Form 3160-5 (June 2019)

| DOK | EAU OF LAND MANAGEMENT | | N | NMNM00090 |
|---|---|-------------------------------|--|--------------------------------------|
| ✓ Oil Well Gas V | Vell Other | | 8. Well Name and No | . AMAZING 19 FED/602H |
| completed. Final Abandonment No is ready for final inspection.) EOG respectfully requests an the following changes: Amazing 19 Fed 714H (FKA 6 Change name from Amazing 1 Change BHL from T-22-S, R-3 to T-22-S, R-32-E, Sec 30, 10 | 19 Fed 602H to Amazing 19 Fed 714H. 32-E, Sec 30, 100' FSL, 1980' FEL, Lea 0 0' FSL, 2310' FEL, Lea Co., N.M. | s, including reclamation, hav | | |

Revised Permit Information 03/09/2023:

885' FNL Revised Wellbore KB: 3660' 2111' FEL GL: 3635'

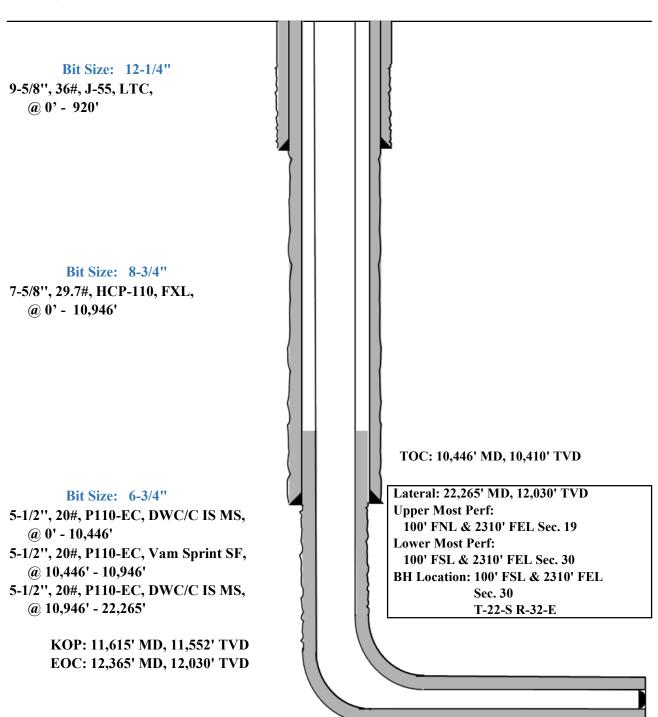
Casing Program:

Variance is requested to waive the centralizer requirements for the 7-5/8" casing in the 8-3/4" hole size. An expansion additive will be utilized, in the cement slurry, for the entire length of the 8-3/4 hole interval to maximize cement bond and zonal isolation.

Variance is also requested to waive any centralizer requirements for the 5-1/2" casing in the 6-3/4" hole size. An expansion additive will be utilized, in the cement slurry, for the entire length of the 6-3/4" hole interval to maximize cement bond and zonal isolation.

Variance is also requested to waive the annular clearance requirements for the 5-1/2" casing by 7-5/8" casing annulus to the proposed top of cement.

885' FNL 2111' FEL **Proposed Wellbore**

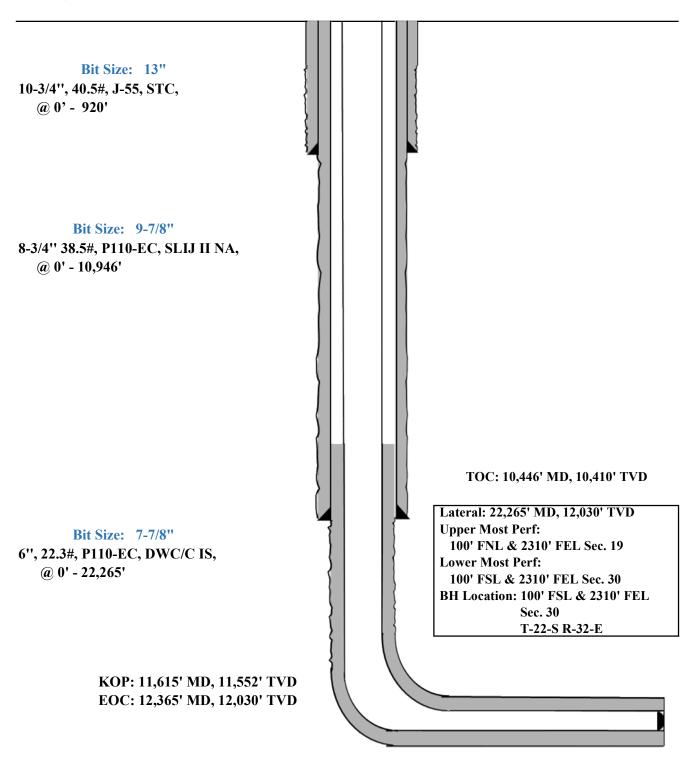
Design B

4. CASING PROGRAM

Variance is requested to waive the centralizer requirements for the 8-3/4" casing in the 9-7/8" hole size. An expansion additive will be utilized, in the cement slurry, for the entire length of the 9-7/8" hole interval to maximize cement bond and zonal isolation.

Variance is also requested to waive any centralizer requirements for the 6" casing in the 7-7/8" hole size. An expansion additive will be utilized, in the cement slurry, for the entire length of the 7-7/8" hole interval to maximize cement bond and zonal isolation.

Variance is also requested to waive the annular clearance requirements for the 6" casing by 8-3/4" casing annulus to the proposed top of cement.
